Adams School Redevelopment

Addendum No. 3 to Contract Documents

March 30, 2012

SHEET
SKA-1

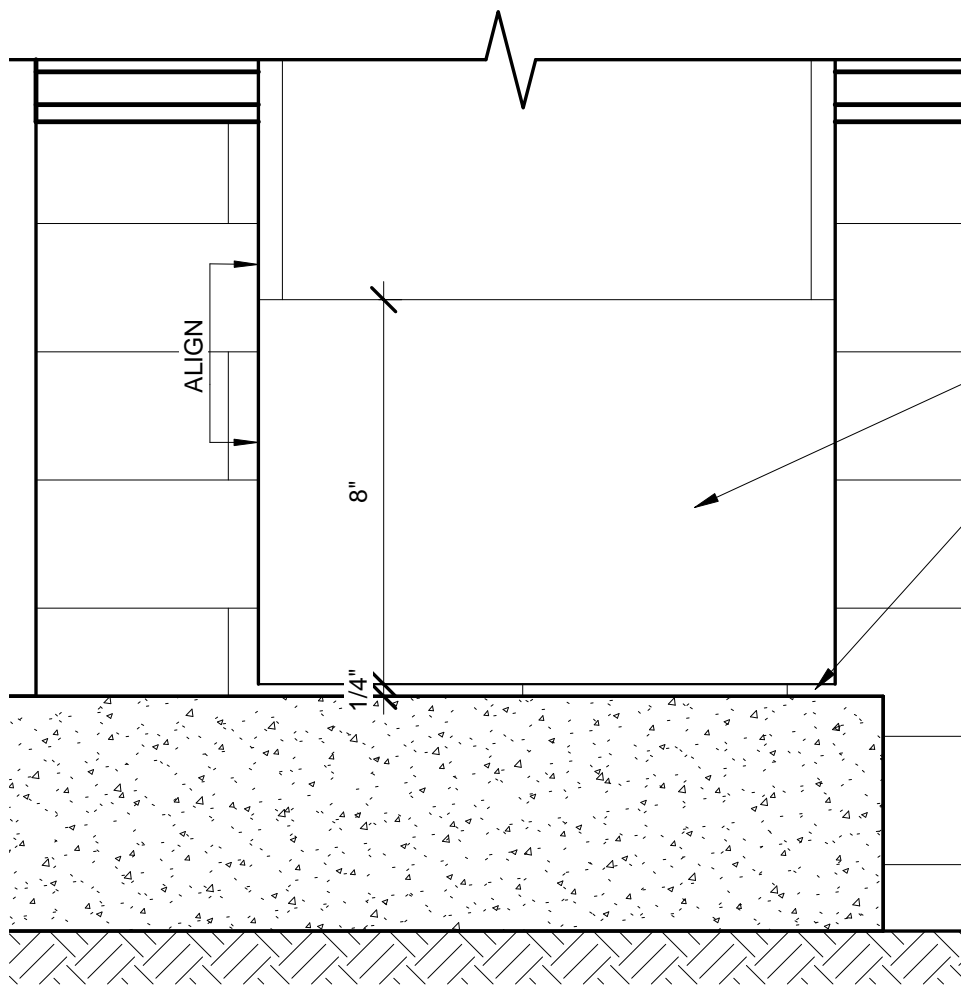
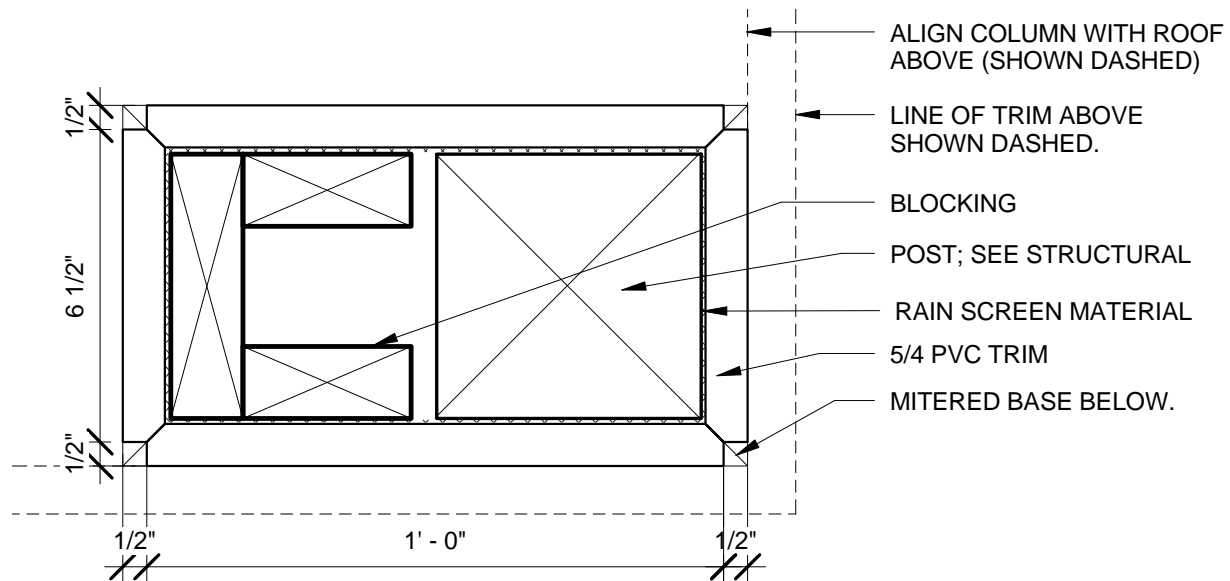
- A. ADD detail SKA-1/Addendum 3 for post wrap at Entry Canopies.
